**Revision to a Request for Supply
Arrangement - Révision à une demande
pour un arrangement en matière
d'approvisionnement**

Title - Sujet Mobilier pour des postes de travail	
Solicitation No. - N° de l'invitation E60PQ-140003/A	Date 2015-04-16
Client Reference No. - N° de référence du client E60PQ-140003	Amendment No. - N° modif. 005
File No. - N° de dossier pq416.E60PQ-140003	CCC No./N° CCC - FMS No./N° VME
GETS Reference No. - N° de référence de SEAG PW-\$\$PQ-416-66821	
Date of Original Request for Supply Arrangement 2015-02-19 Date de demande pour un arrangement en matière d'app. originale	
Solicitation Closes - L'invitation prend fin at - à 02:00 PM on - le 2015-05-28	
Address Enquiries to: - Adresser toutes questions à: Clouthier, Chantal	Buyer Id - Id de l'acheteur pq416
Telephone No. - N° de téléphone (819) 956-7184 ()	FAX No. - N° de FAX () -
Delivery Required - Livraison exigée	
Destination - of Goods, Services, and Construction: Destination - des biens, services et construction:	
Security - Sécurité This revision does not change the security requirements of the solicitation. Cette révision ne change pas les besoins en matière de sécurité de l'invitation.

This amendmen

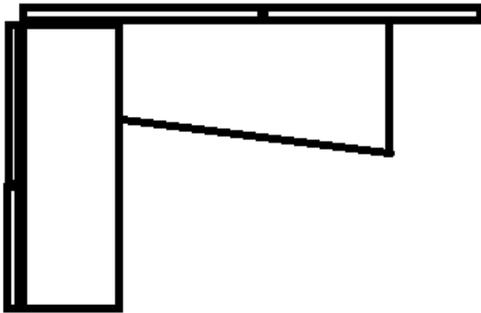
GoC code "wsffxhpt2g" - Transitional surfaces with 2 full gables and modesty. There is no definition of Transitional surfaces in Annex B. Please define. If you are referring to a surface with one depth of i.e. 30"d and the other at 24"d, on either end of the surface, then this was typically used with a corner surface. Corners are not requested in this bid. Please advise.

A.73: Yes your description is correct. See Section 2 Modifications, modification (N).

See diagram below as an example :
